CITY OF AUSTIN Board of Adjustment Decision Sheet

DATE: Monday October 14, 2019 CASE NUMBER: C15-2019-0055

RE: 2803 EDGEWATER DR. VARIANCE REQUEST - UPDATED

2803 EDGEWATER VARIANCE REVISION NOTES: Highlighted Points

REVISED IMPERVIOUS COVER TABULATIONS BOA HEARING 11/07/19

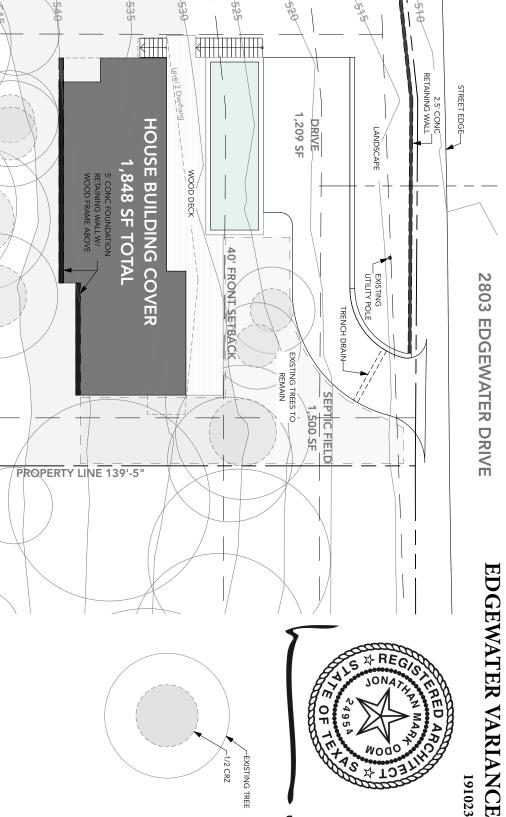
- 1. Please include Neighbor Letters / Meeting Feedback
- 2. Footprint of house has decreased from 2,233SF to 1,848 SF
- 3. Impervious cover at 25%-35% Zone has decreased: from 66% to 59%

- 4. Impervious cover Over 35% Zone has decreased: from 29% to 17%
- 5. Detention is not required per residential code we are proposing detention
- 6. Structural Engineer has provided a letter indicating that Pier and Beam is not a viable solution for this project.

- 7. Soil Report is provided Bedrock below 24 inches.
- 8. Pool length has been decreased. Pool elevation has also been dropped in consideration to cut and fill

- 9. Cut and Fill minimized and balanced per section.
- 10. Surveyed Trees are in drawings indicating trees to remain and trees to be removed.
- 11. Retaining walls are limited to 4 feet per code
